**METROPOLITAN GOVERNMENT OF NASHVILLE AND DAVIDSON COUNTY**

**STAFF RECOMMENDATION**  
**1910 19<sup>th</sup> Avenue South**  
**November 19, 2018**

**Application:** New Construction—Addition and Outbuilding (Detached Accessory Dwelling Unit)

**Description of Project:** The applicant proposes to construct and addition to the house and lateral and rooftop additions to the existing outbuilding for use as a detached accessory dwelling unit. The outbuilding is to be converted to a detached accessory dwelling unit.

Figure 2: Existing outbuilding

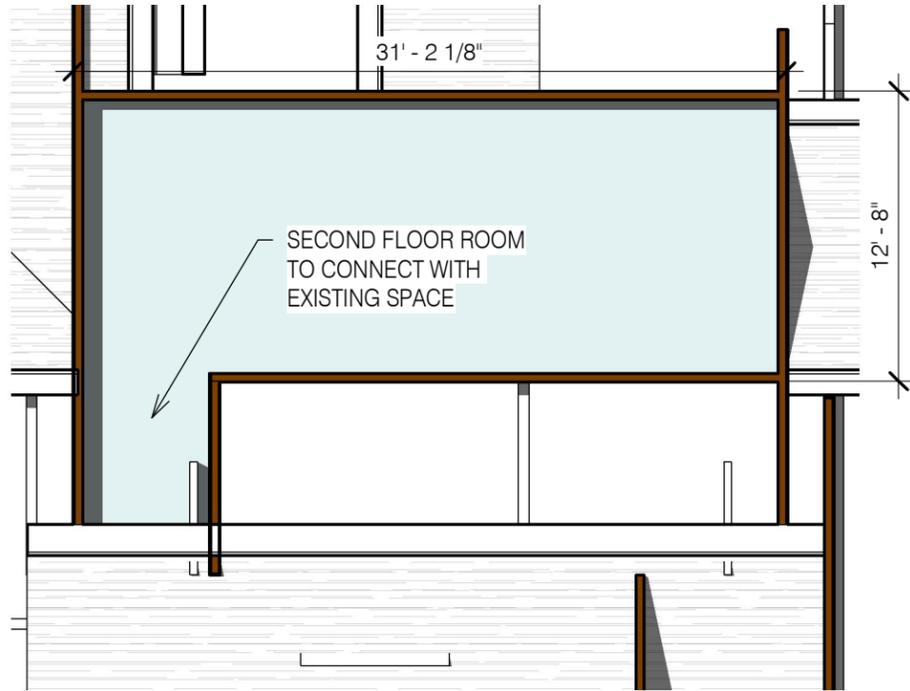
The only addition to the footprint of the existing outbuilding will be a covered side stoop with posts that go to the ground that is to be located on the right side elevation. In the past, the Commission has included this type of covered space in the overall footprint. The covering is approximately seven feet, six inches (7’-6”) by five feet (5’), which would add thirty-eight square feet (38 sq. ft.) to the footprint.

The project includes removing the existing roof on the outbuilding and replacing it with a taller cross-gabled roof form. As proposed, the alterations meet the design guidelines for ridge and eave heights.

**3 SECOND FLOOR**  
A-1 1/8" = 1'-0"

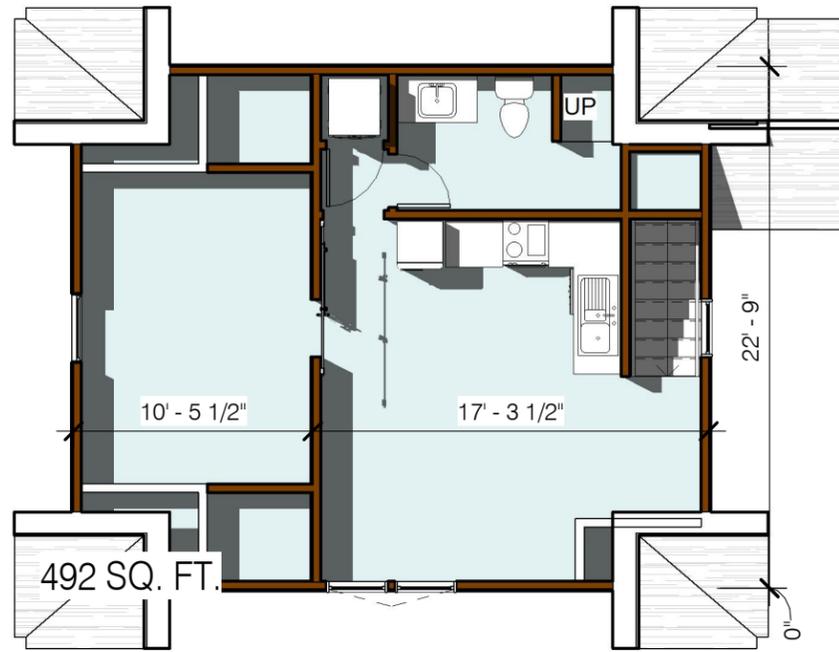
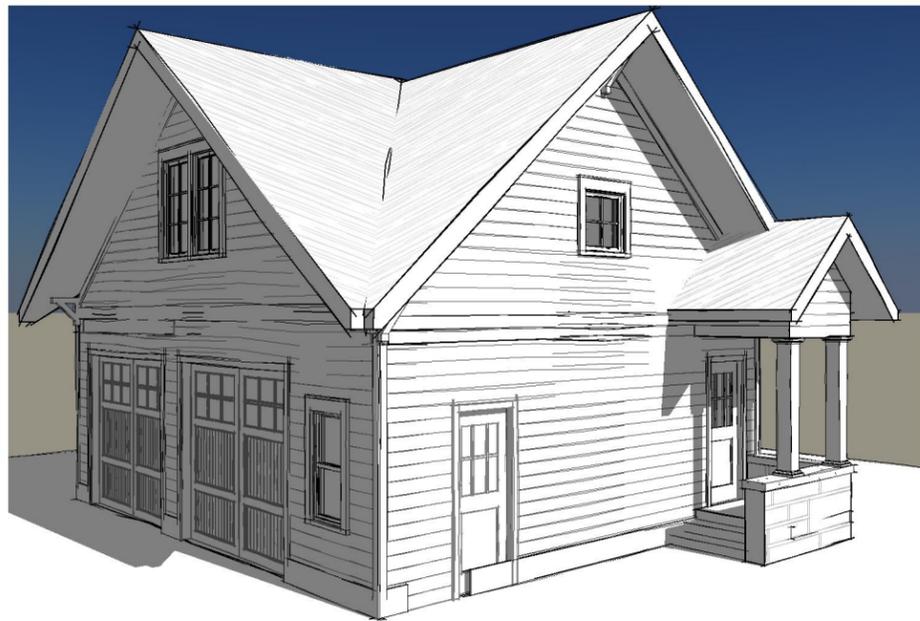
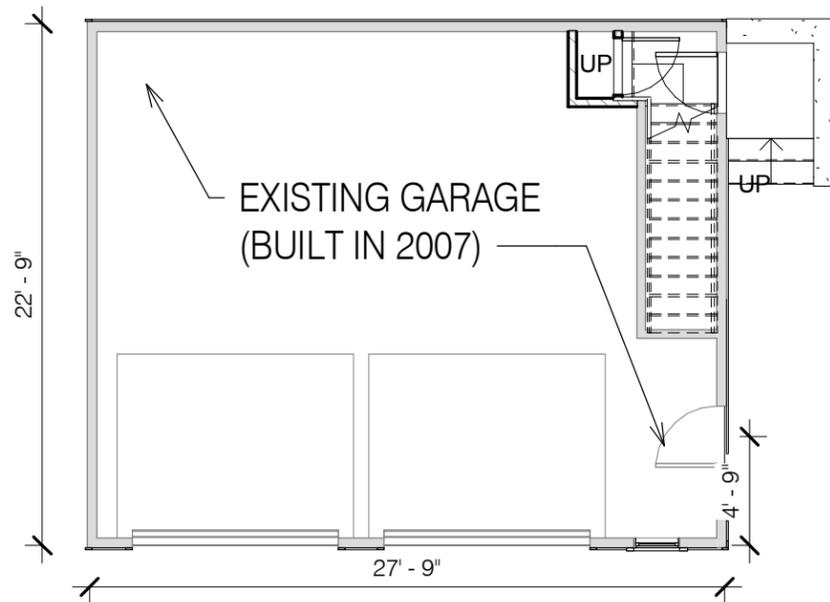
1. A revised roof plan or second floor plan shall be submitted that shows the building footprint/walls below so that staff can confirm the insets of the new addition;
2. Staff shall review the trim, roofing material color, and windows for the addition prior to purchase and installation; and
3. Staff shall review and approve all materials for the outbuilding prior to purchase and installation.

Design: The design of the addition mimics the existing home with a similar roof form. The plan indicates that it will be differentiated from the historic house by setting in two feet from the side walls of the historic house. Staff recommends that a either a revised roof plan or second floor plan be submitted that shows the building footprint/walls so that staff can confirm the insets of the new addition. With this condition, staff finds that the project meets section II.B.2.a and f.

1. A revised roof plan or second floor plan shall be submitted that shows the building footprint/walls below so that staff can confirm the insets of the new addition;
2. Staff shall review the trim, roofing material color, and windows for the addition prior to purchase and installation; and
3. Staff shall review and approve all materials for the outbuilding prior to purchase and installation.
